**RE: BID NO. 11ITB110911K-NH T211 SR 279/OLD NATIONAL HIGHWAY ATMS  
FULTON COUNTY PROJECT STP-0000-00(189), (CT 1) P.I. No. 0000189**

11ITB110911K-NH T211 SR 279/OLD NATIONAL HIGHWAY ATMS FULTON COUNTY  
PROJECT STP-0000-00(189), (CT 1) P.I. No. 0000189  
Addendum No. 1  
Page Two

### ACKNOWLEDGEMENT OF ADDENDUM NO. 1

**DECORATIVE STEEL STRAIN POLE DETAIL**

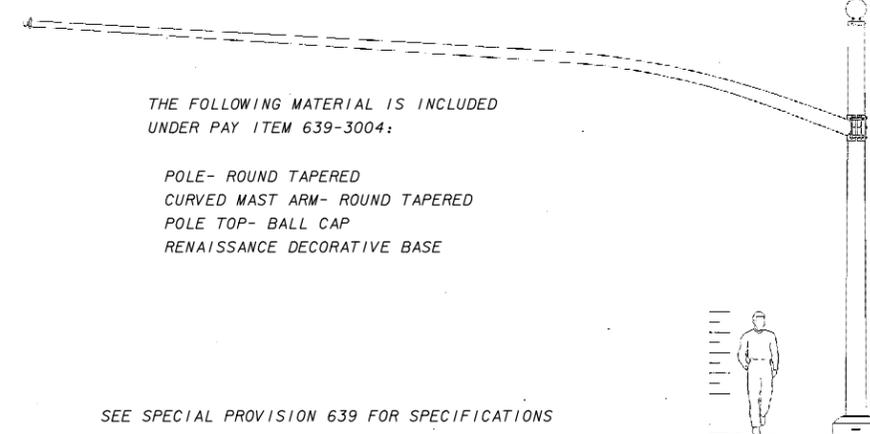
My company, is a supplier who will be providing pricing to some of the contractors who will bid this project. One of the items that we supply are signal strain poles/mast arm poles. We have purchased the documents, but cannot find detailed specifications concerning the decorative bases for the signal poles. All we have found is that they are to be decorative. Can you please forward the actual specifications (manufacturers name, part number, drawings) of these bases at your earliest convenience please?

Please see the attached documents.
